PLANTING PLAN

CENTRAL PARK
DETAILS

CENTRAL PARK CAFE ENLARGEMENT PLAN

CENTRAL PARK CAFE DETAILS

01 CU STRUCTURAL SOIL per C-ST-109
N.T.S.

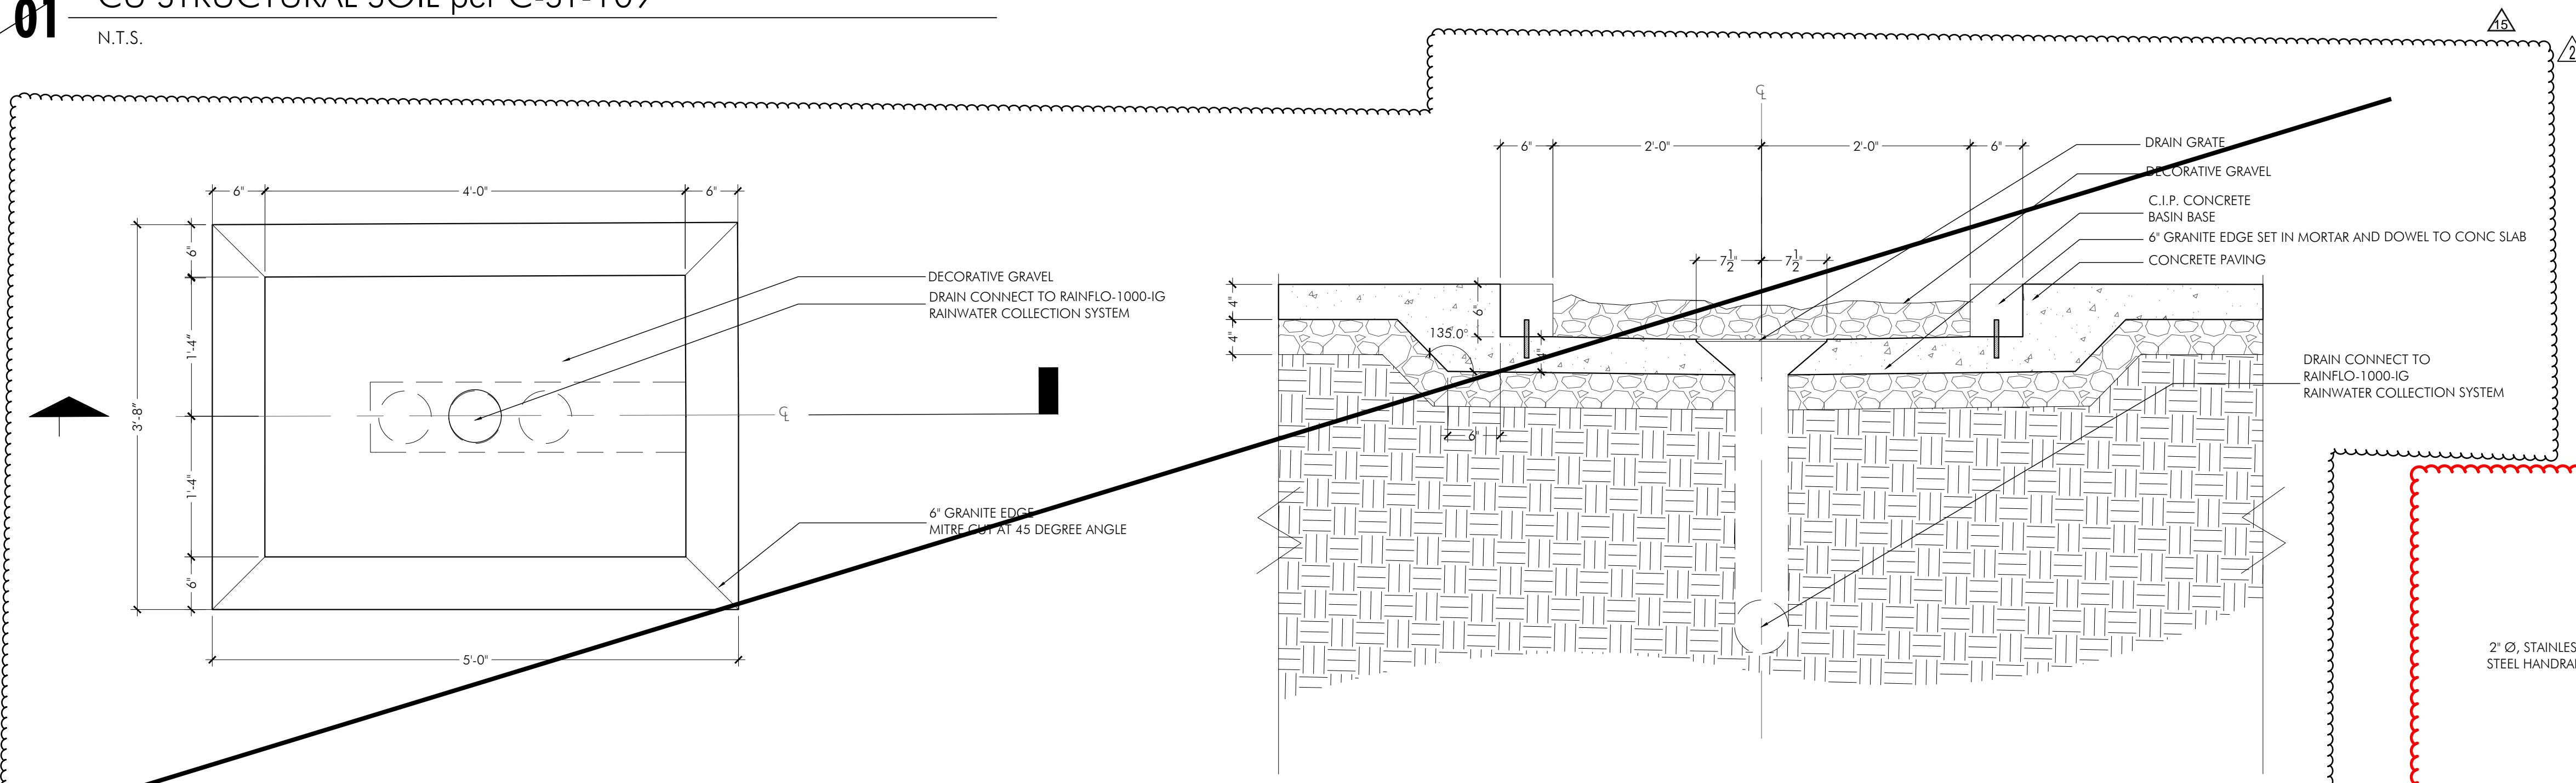
NOTE:
SEE CENTRAL PARK PLAN FOR LOCATIONS. CU STRUCTURAL SOIL TO BE INSTALLED ON THE NORTH AND SOUTH SIDES OF TREE PIT, NOT THE OPPOSITE SIDE OF THE CURB.

05 KIOSK SECTION 5

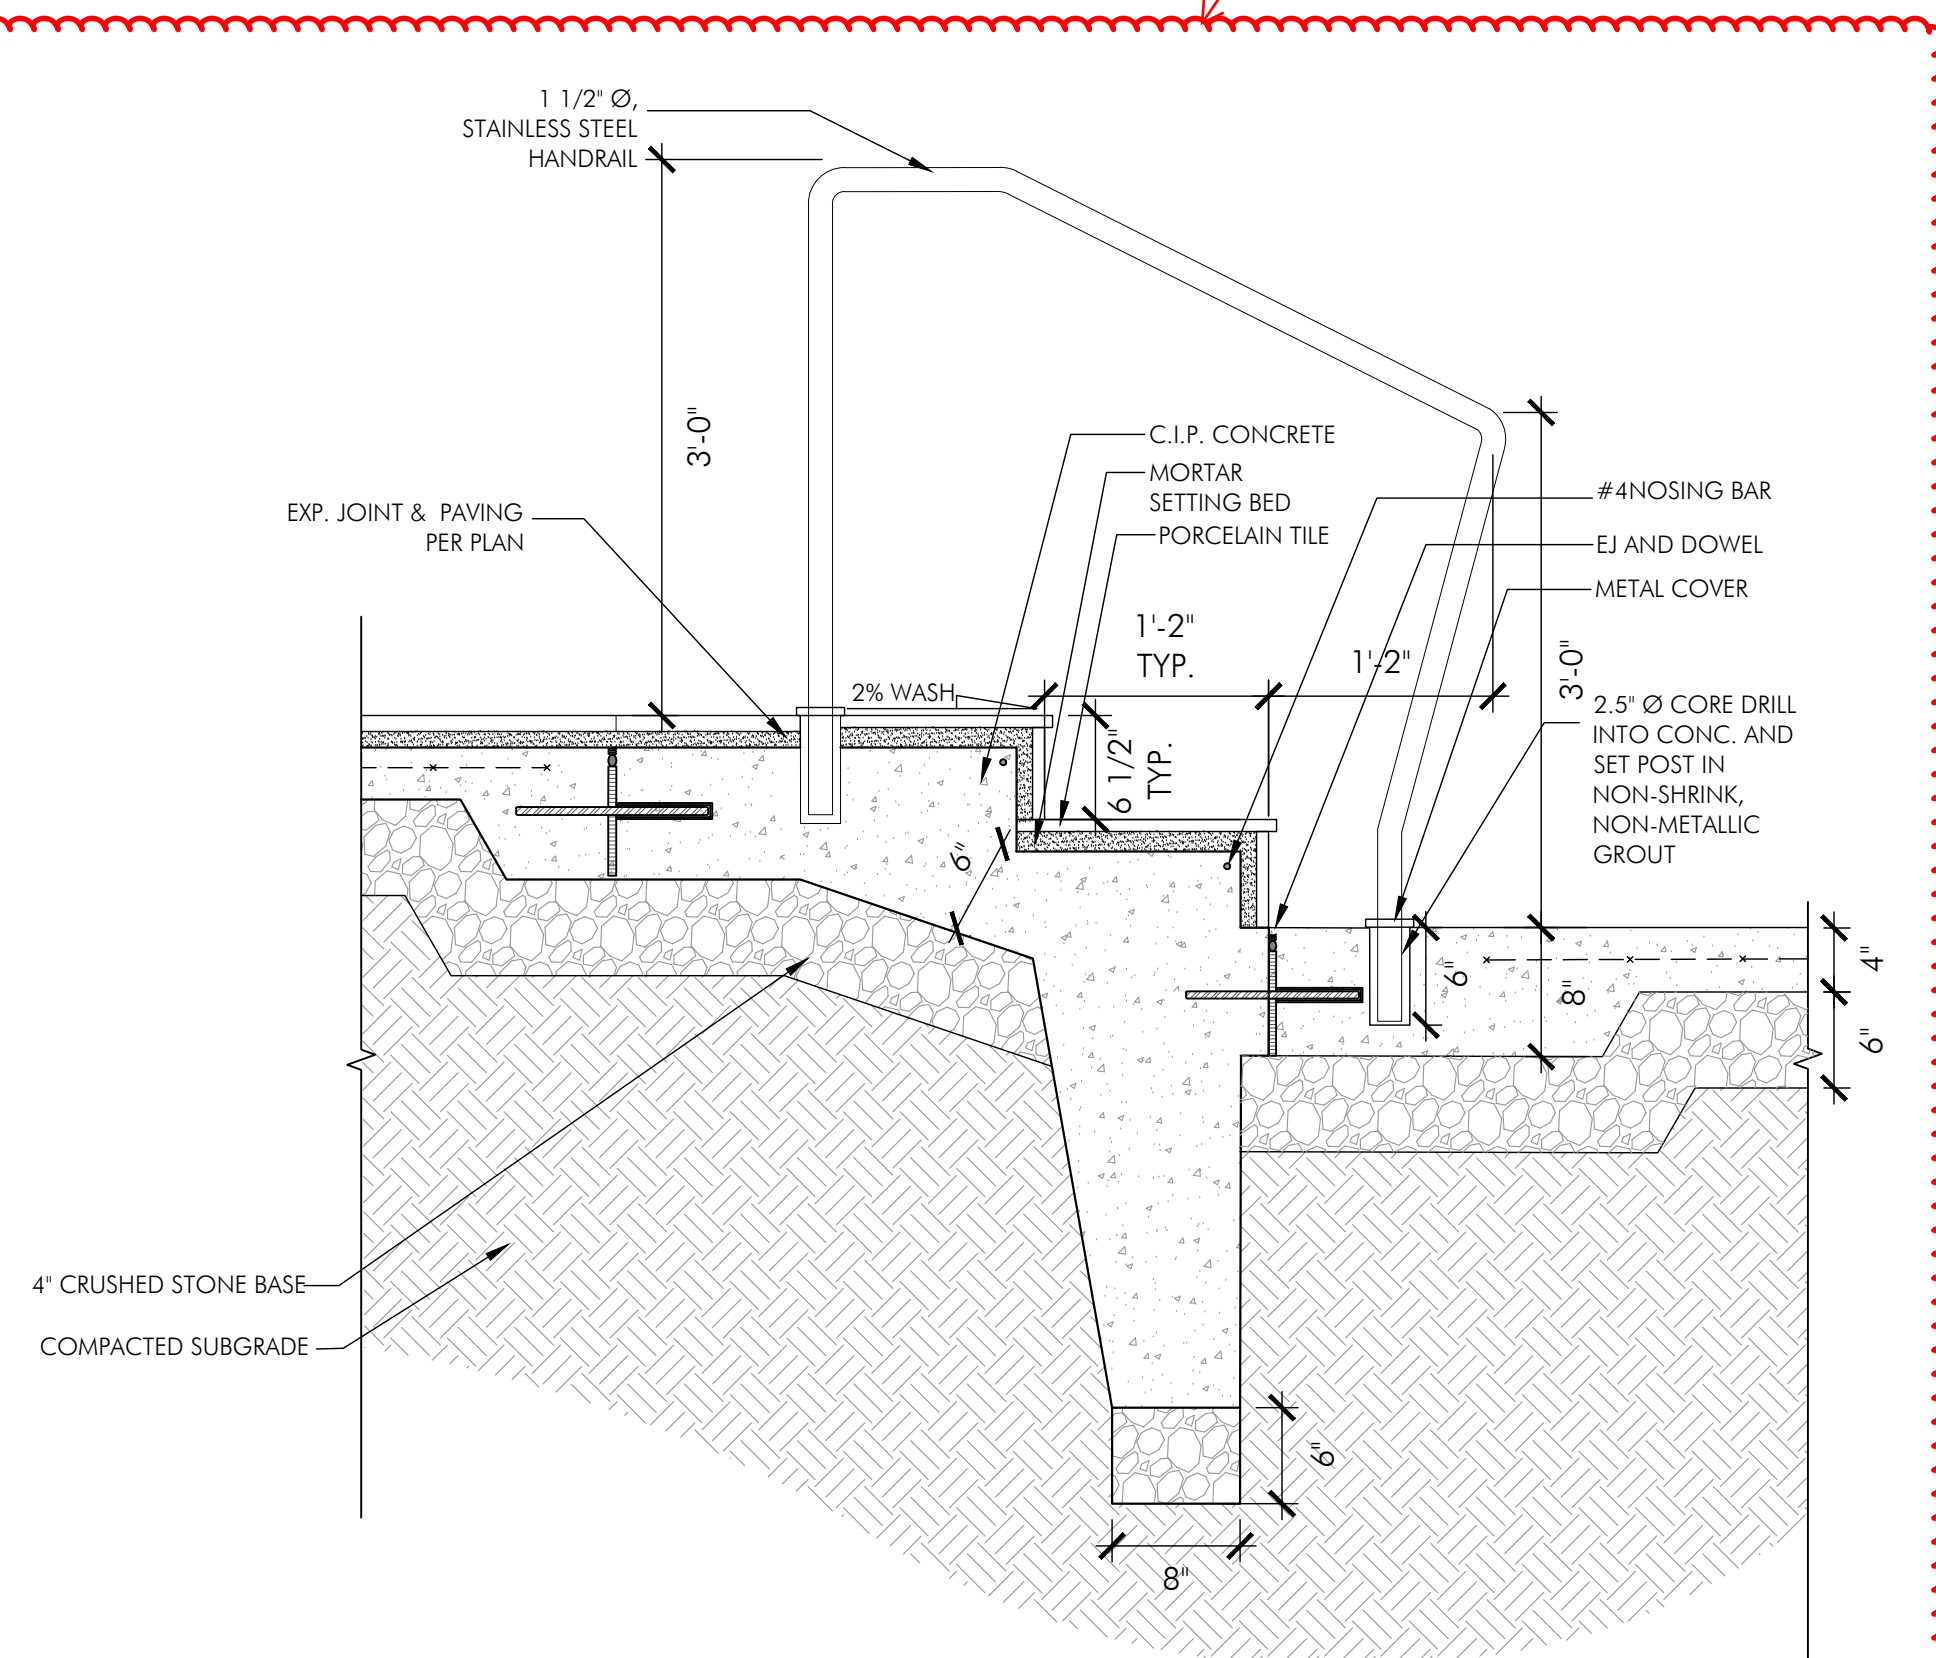
Only this handrail detail to be included in the Kiosk project.
